CERTIFICATE OF APPROPRIATENESS

**RE: Application Number 21-7194; 1627 (1627-1639) LEVERETTE; Corktown
Historic District**

Project:
Leverette Apartments - Exterior Corrections
Existing Apartment Renovations
Leverette Development, LLC
1627 Leverette Street
Detroit, Michigan 48216

**Car Port Plan
and Elevation**

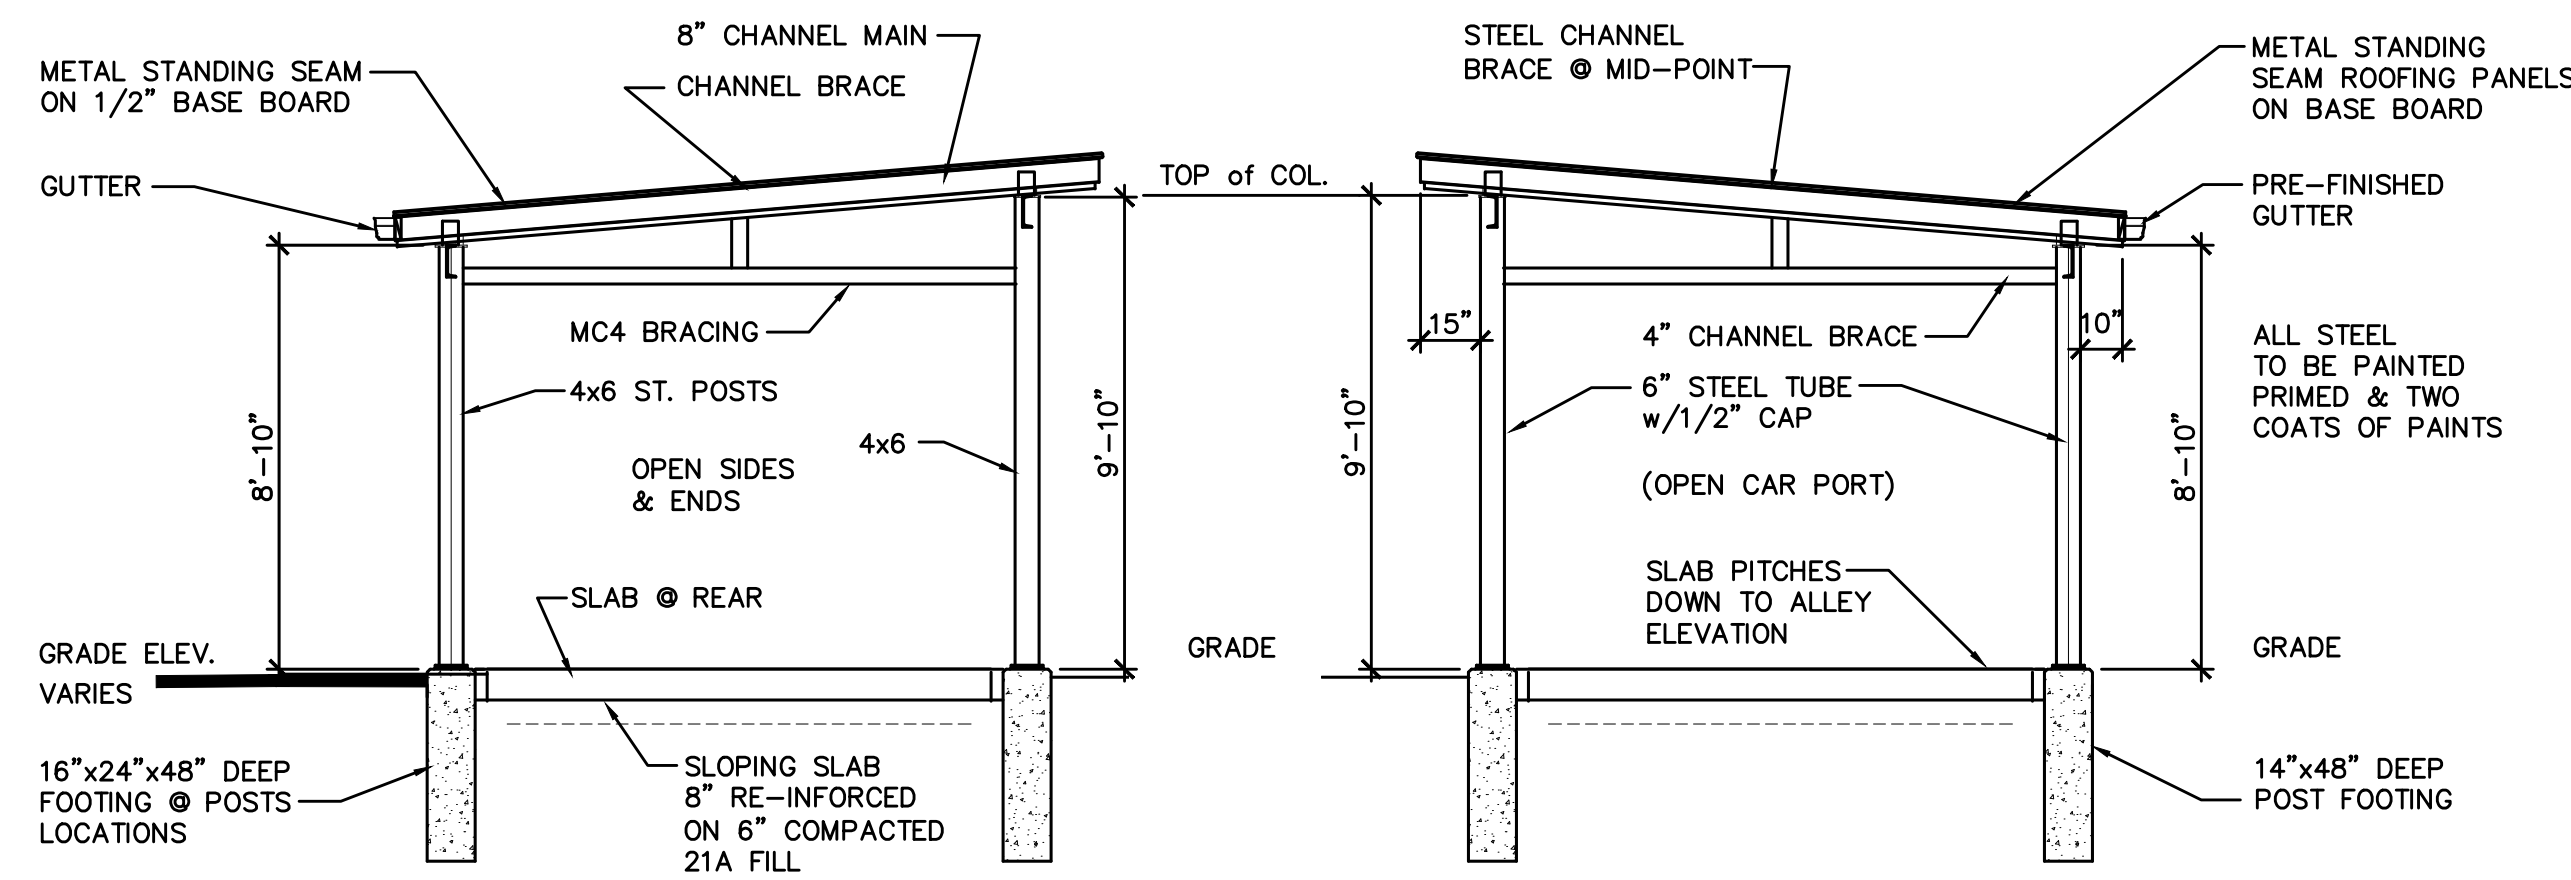
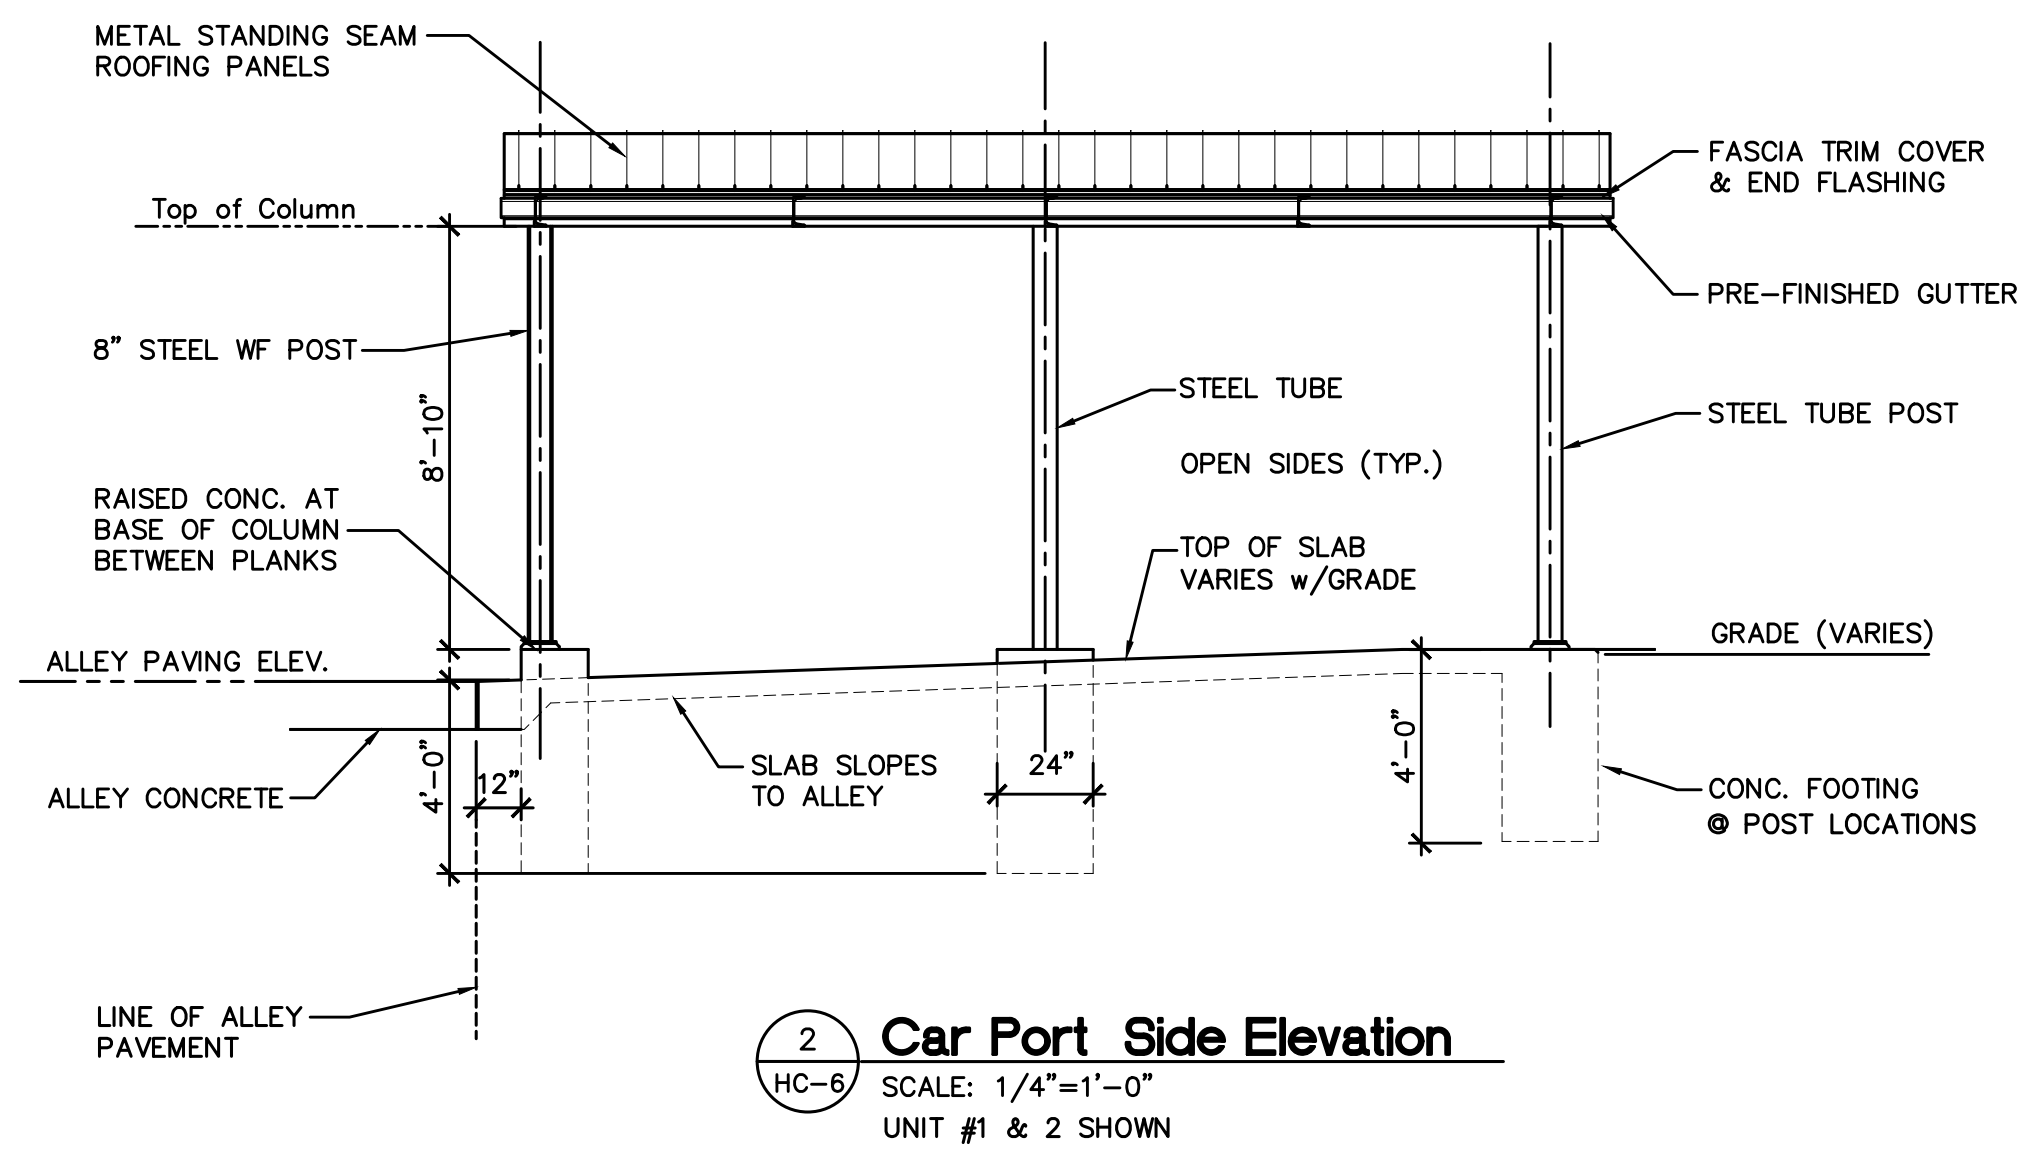
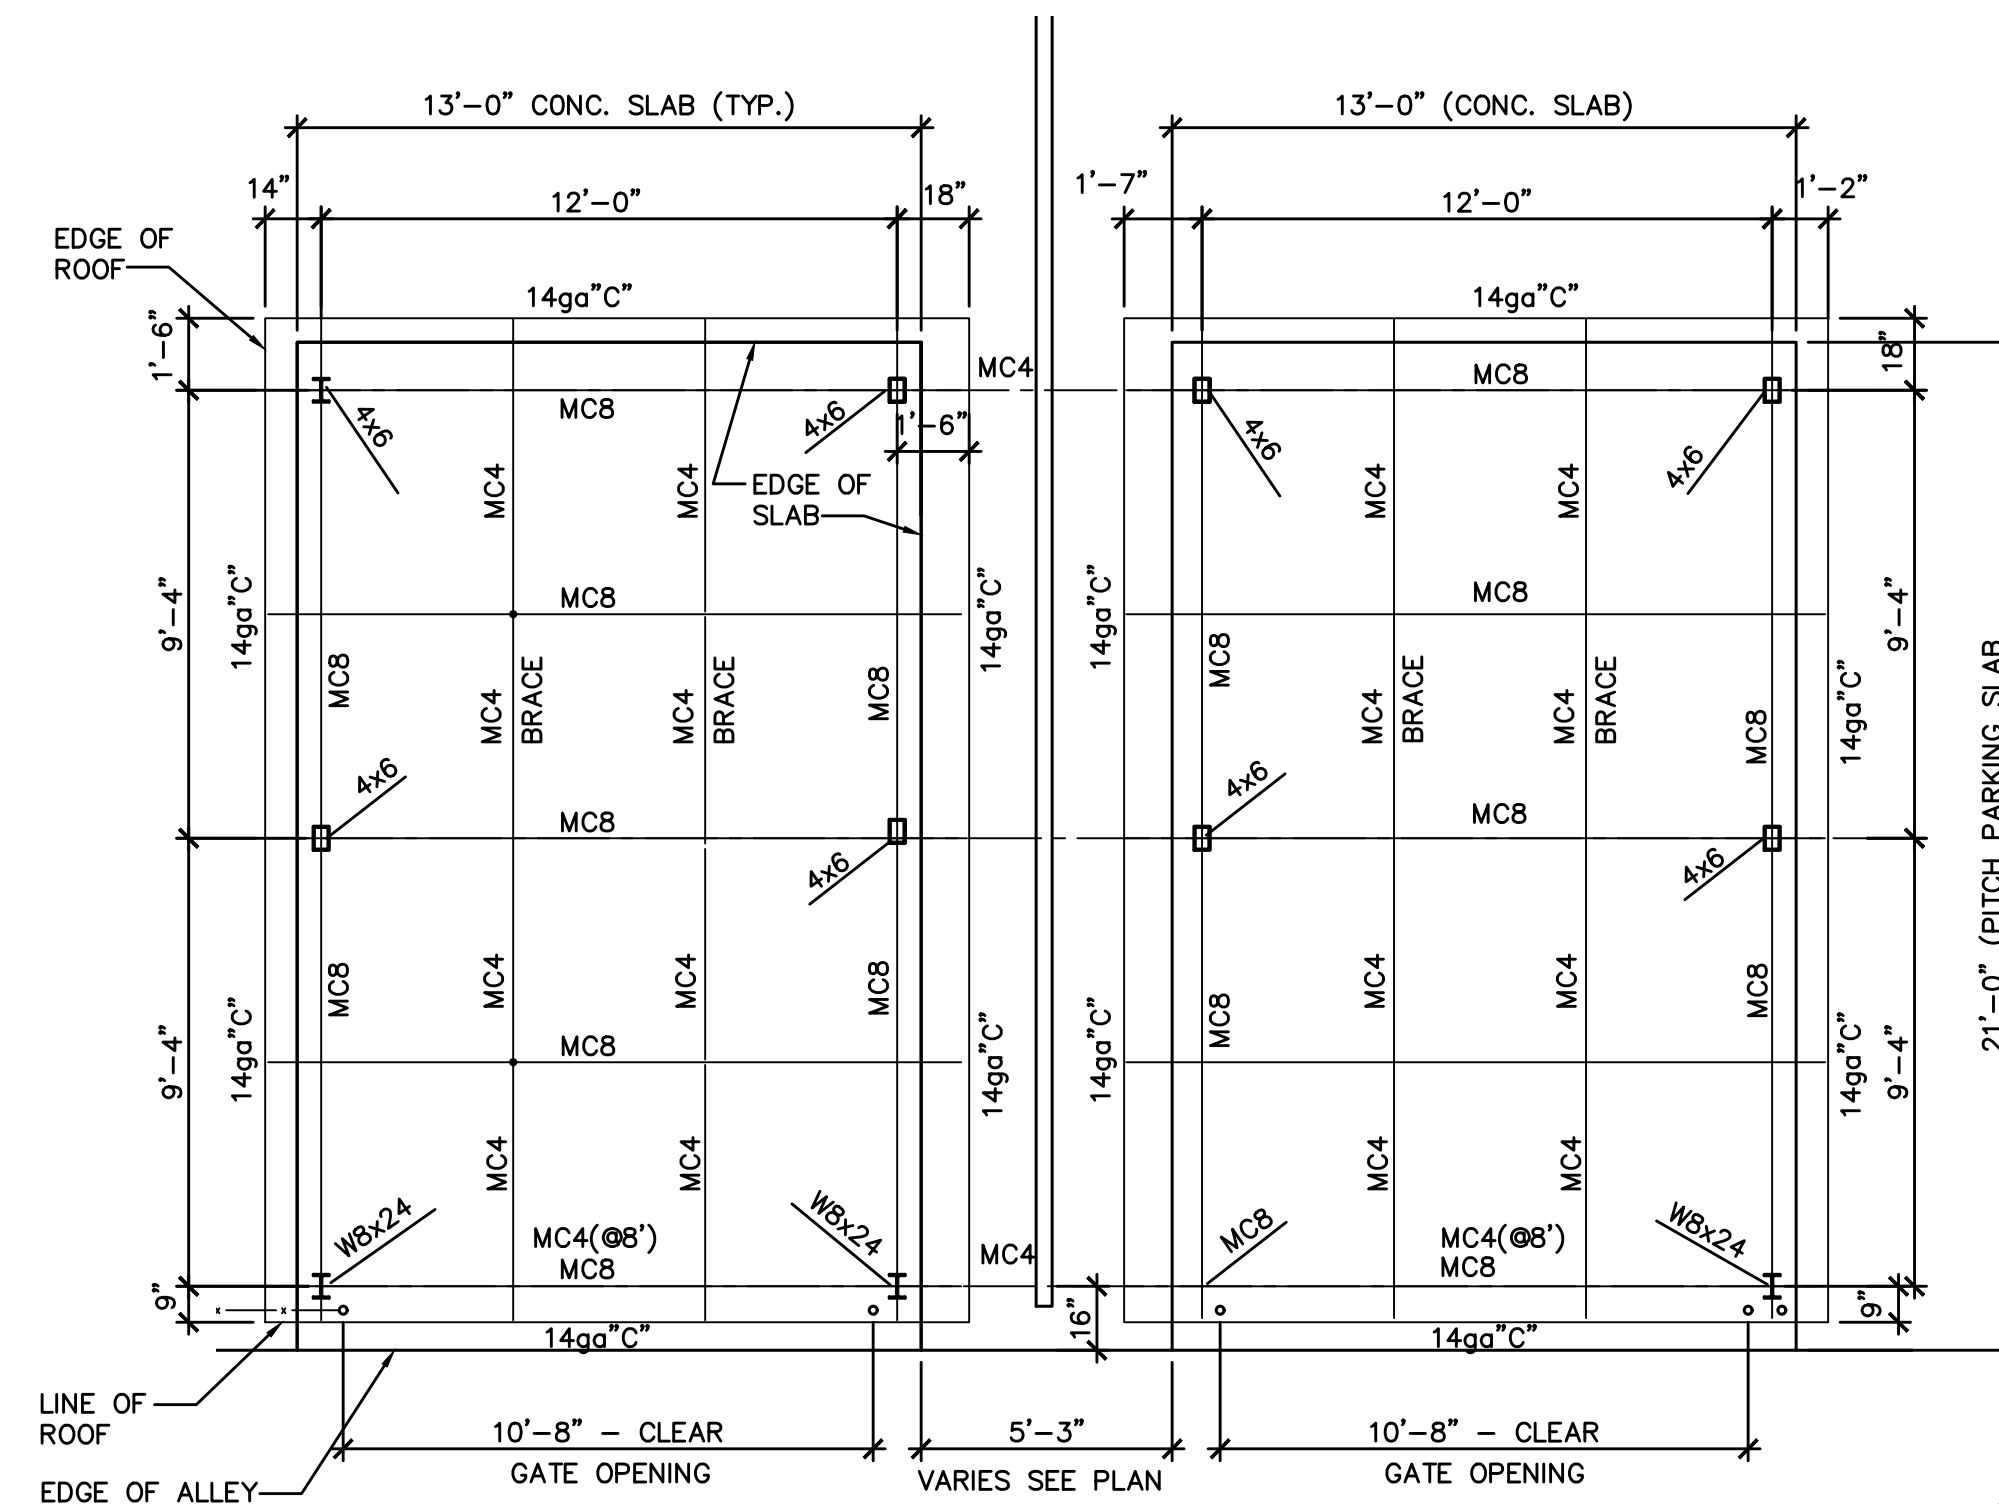
- At the rear yard of each of the seven units, erect a wood, shed-roof new open carport as per the attached with a footprint of 15'-8"x23'-4," 14-10'x23'-4" or 13'-0"x23'-4" concrete footprint.
- At rear yard, install a new concrete walkway which leads from each new porch to proposed new carport (**work completed**)
- At rear yard, directly north of the new carports, erect a new wood (with horizontal slats) fence which measures 6'-0" high to enclose backyards of all units (**work completed**). The fence will be stained brown
- At the rear property line, at the alley, erect new 6'-0"-tall chain link fencing which will open to the new carports
- At rear yard of each unit, install an HVAC condenser unit

- Any exterior wood elements proposed for the new carports cannot be unfinished. Rather, they must be stained or painted a color which complements the building. The owner or applicant shall submit a proposal to HDC staff outlining the color palette for the garages’ wood elements for review and approval prior to staff’s approval/signoff of the project’s final construction drawings. Also, these elements must be painted or stained as per the approved color scheme on or before April 14, 2022.
